Access Assessment Report

21-23 Phillips Ave & 5 Richardson Ave, Regents Park

Project:	21-23 Phillips Ave & 5 Richardson Ave, Regents Park
Reference No:	112541-Access-r3
Date:	30 November 2020
Client:	Barry Rush & Associates Pty Ltd
Client Contact:	Barry Rush
Email:	barry@barryrush.com.au
BCA Logic Contact:	Matthew Kemp
Direct:	8484 4055
Email:	mkemp@bcalogic.com.au

Clause 26 Location and access to facilities

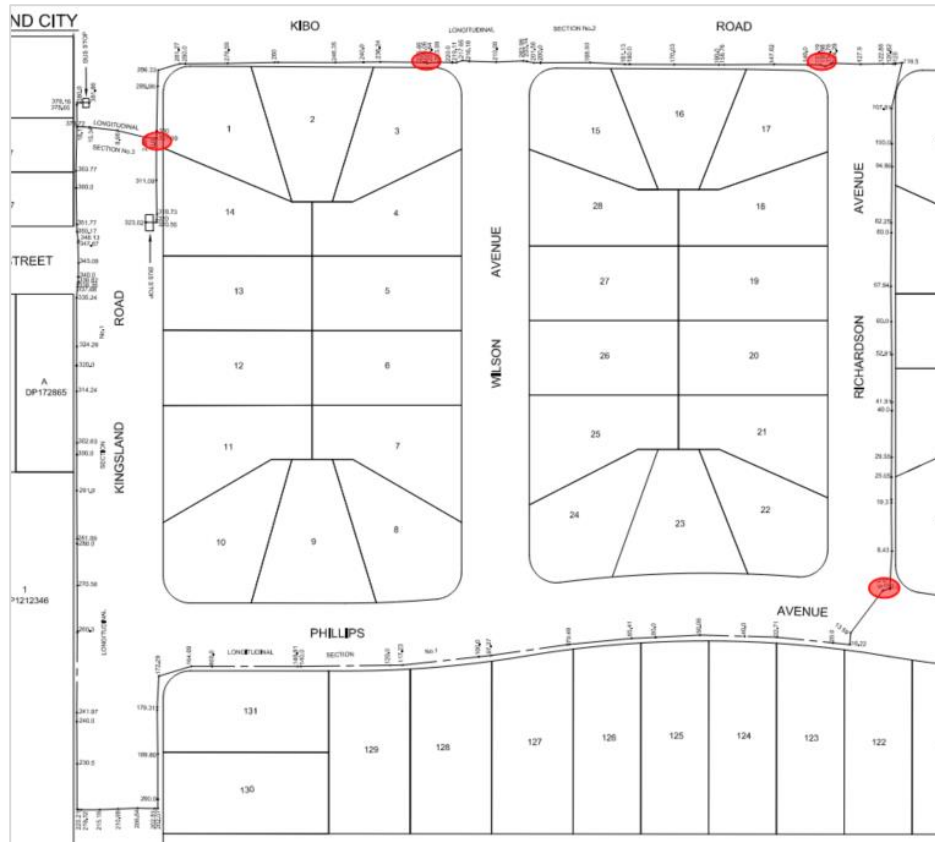
Clause	Requirements
1	<p>Residents of the proposed development are required to have access that complies with subclause (2) to:</p> <ul style="list-style-type: none"> a) shops, bank service providers and other retail and commercial services that residents may reasonably require, and b) community services and recreation facilities, and c) the practice of a general medical practitioner. <p>Discussion</p> <p>The Public Transport service provides connection with retail and service precincts that have the facilities outlined by this Clause.</p>
2	<p>Access complies with this clause if:</p> <ul style="list-style-type: none"> a) in the case of a proposed development on land in a local government area that is not within the Greater Sydney (Greater Capital City Statistical Area)—there is a transport service available to the residents who will occupy the proposed development: <ul style="list-style-type: none"> i. that is located at a distance of not more than 400 metres from the site of the proposed development and the distance is accessible by means of a suitable access pathway, and ii. that will take those residents to a place that is located at a distance of not more than 400 metres from the facilities and services referred to in subclause (1), and iii. that is available both to and from the proposed development during daylight hours at least once each day from Monday to Friday (both days inclusive), iv. and the gradient along the pathway from the site to the public transport services (and from the transport services to the facilities and services referred to in subclause (1)) complies with subclause (3). <p>Discussion</p> <p>The development is within 400m of public transport services, in the form of bus stops on Kingsland Road. Highlighted on the diagram below. Both of the stops are serviced by a Bus Public Transport Service known as Route 909 (Refer Annexure # for Route Details). The Bus Route provides connection Bankstown and Parramatta Cities, stopping at various town centres between.</p>

Clause	Requirements
	<p>The overall average gradient along a pathway from the site of the proposed development to the public transport services (and from the transport services to the facilities and services referred to in subclause (1)) is to be no more than 1:14, although the following gradients along the pathway are also acceptable:</p> <ol style="list-style-type: none"> a gradient of no more than 1:12 for slopes for a maximum of 15 metres at a time, a gradient of no more than 1:10 for a maximum length of 5 metres at a time, a gradient of no more than 1:8 for distances of no more than 1.5 metres at a time. <p>Discussion</p> <p>A land survey of the route has been prepared by YSCO Geomatics and is referenced in Annexure A of this Report. It demonstrates that there are two appropriate travel routes available between the site and bus stops within Kingsland road. The points highlight in the figure below would require reconstruction to achieve the required gradients, however it is considered that this could be readily achieved. Only one of the survey routes would be needed to achieve compliance.</p>
